VIRGINIA ELECTRIC AND POWER COMPANY
RICHMOND, VIRGINIA 23261

January 4, 2001

VIRGINIA ELECTRIC AND POWER COMPANY
NORTH ANNA POWER STATION UNITS 1 AND 2
RESPONSE TO REQUEST FOR ADDITIONAL INFORMATION
PROPOSED TECHNICAL SPECIFICATIONS CHANGES
REACTOR COOLANT SYSTEM PRESSURE/TEMPERATURE LIMITS
LTOPS SETPOINTS, AND LTOPS ENABLE TEMPERATURES

| Attachment 2 | Mark-up of Units 1 and 2 Technical Specifications Changes |

Figure 3.4-3 — North Anna Unit 2
Reactor Coolant System Cooldown Limitations

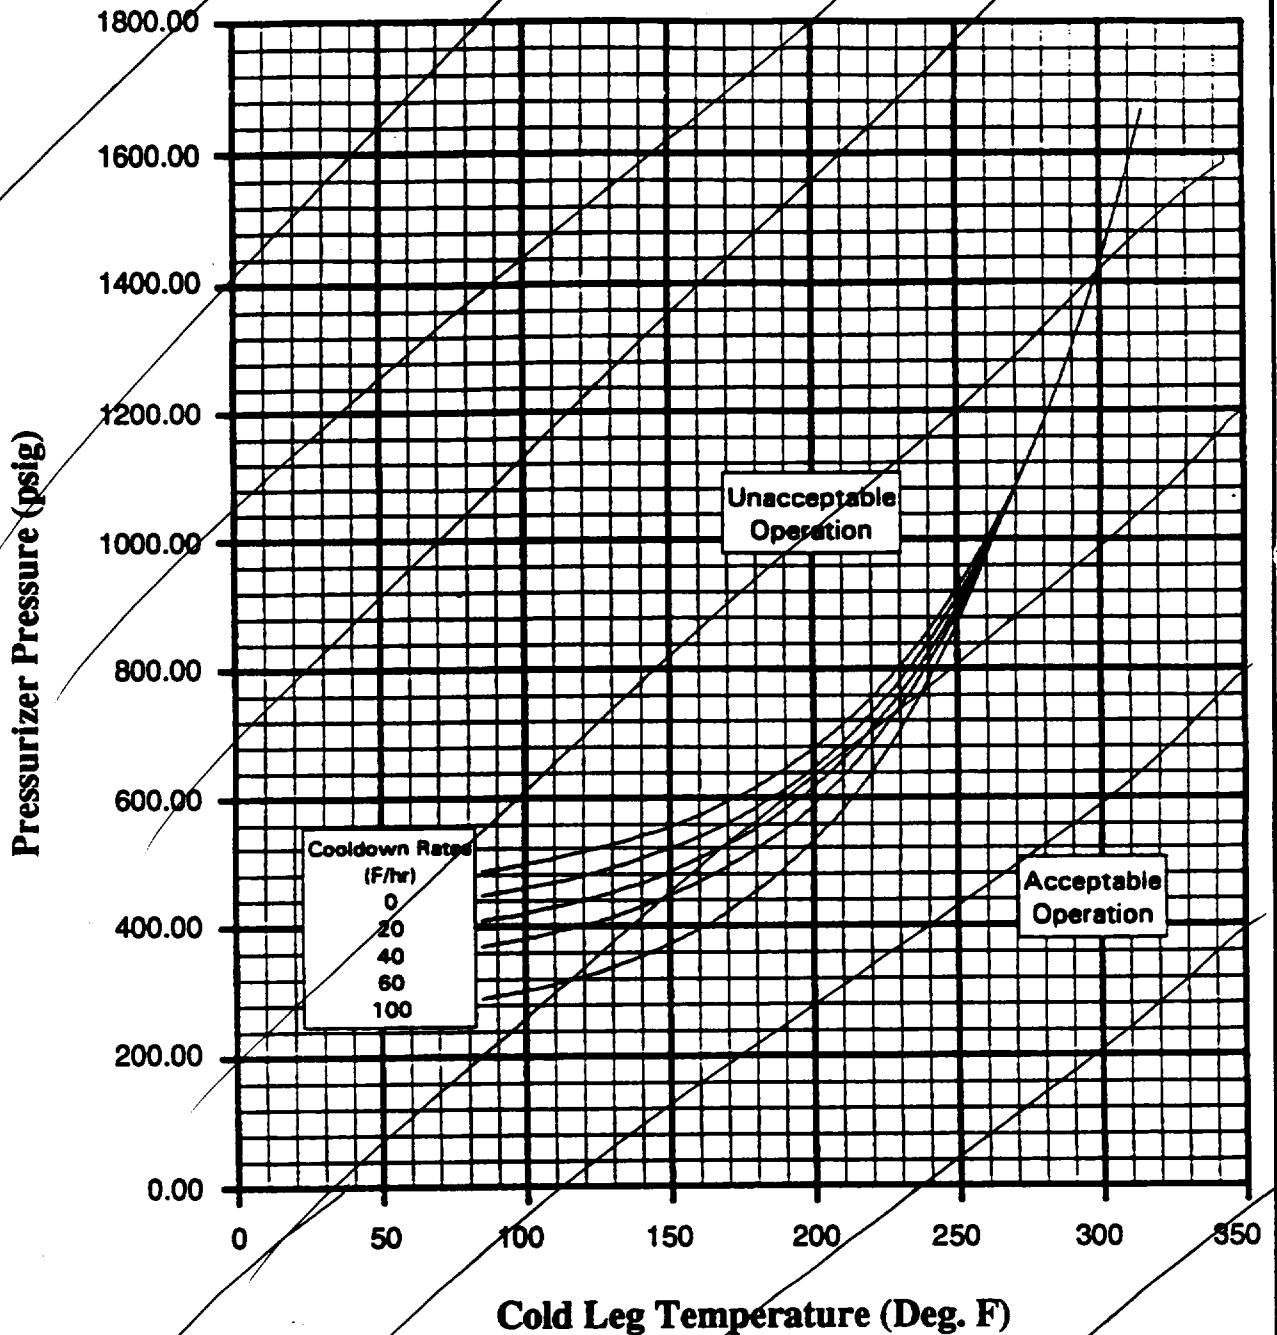
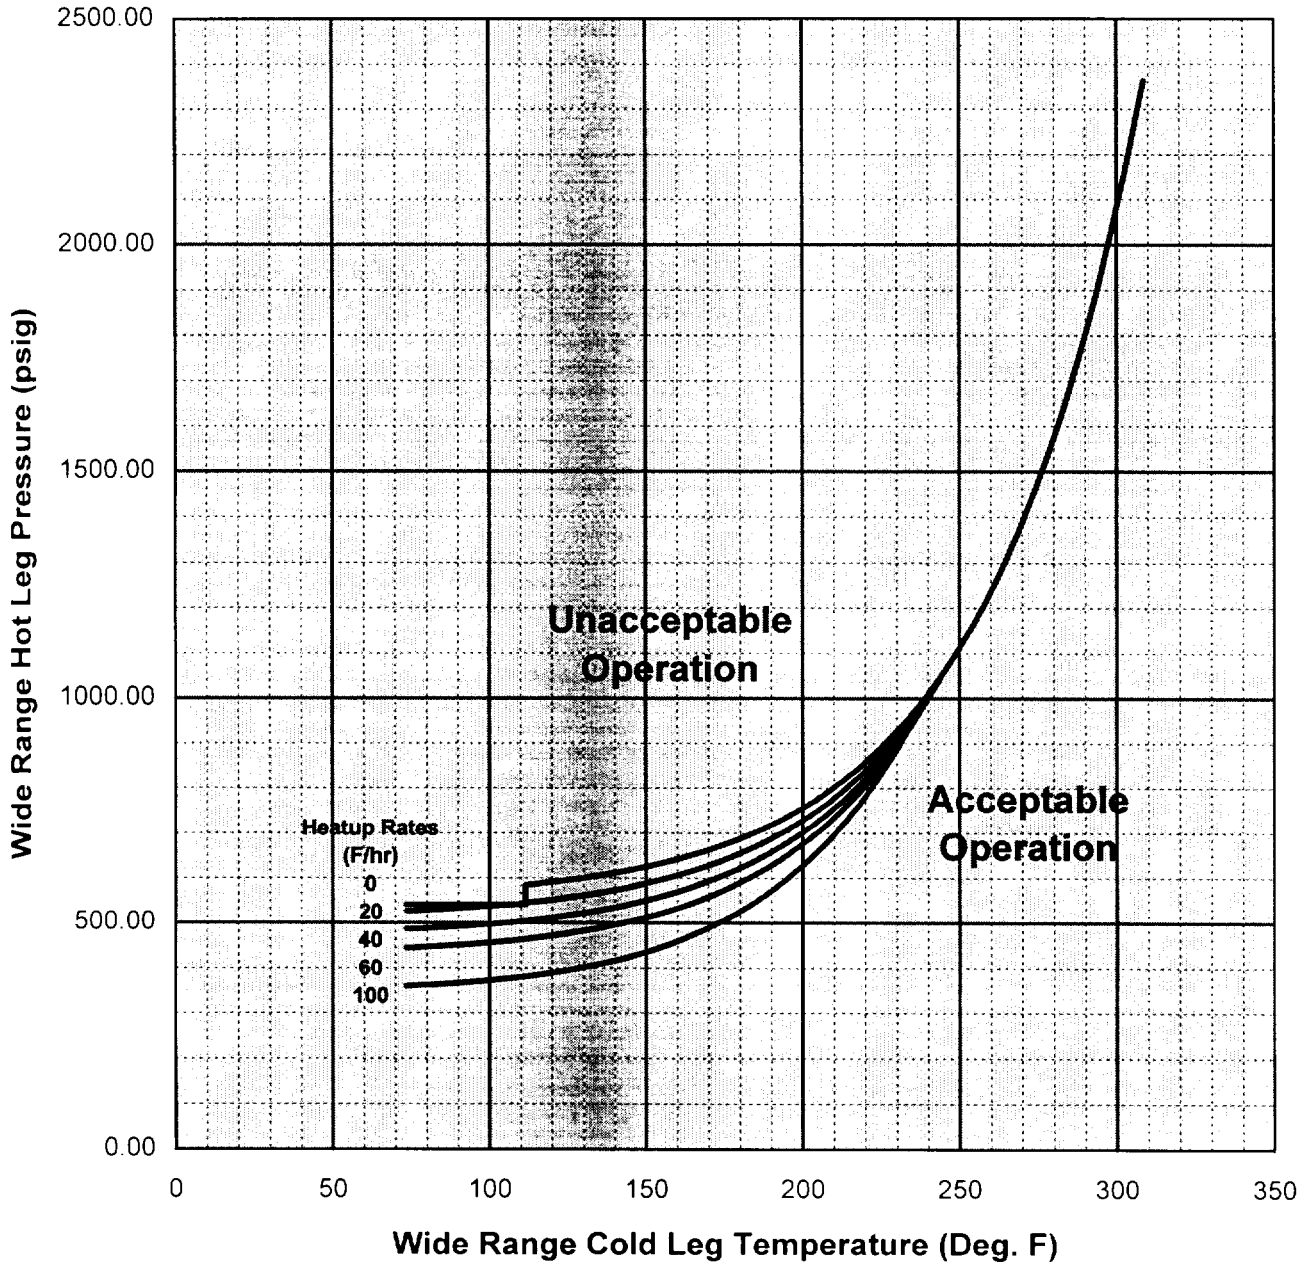
The reactor vessel materials have been tested to determine their initial RT_{NDT} . Reactor operation and resultant fast neutron ($E > 1$ Mev) irradiation will cause an increase in the RT_{NDT} . ~~An adjusted reference temperature, based upon the fluence and copper content of the material in question, can be predicted using US NRC Regulatory Guide 1.98, Revision 2. The heatup and cooldown limit curves (Figure 3.4-2 and Figure 3.4-3) include predicted adjustments for this shift in RT_{NDT} at the end of 17 EFPY. The reactor vessel beltline region material properties are listed on Figures 3.4-2 and 3.4-3.~~

North Anna Unit 2 Reactor Coolant System Cooldown Limitations (Cooldown Rates up to 100 F/hr)
Applicable for the first 34.3 EFPY (Including Margins for Instrumentation Errors)
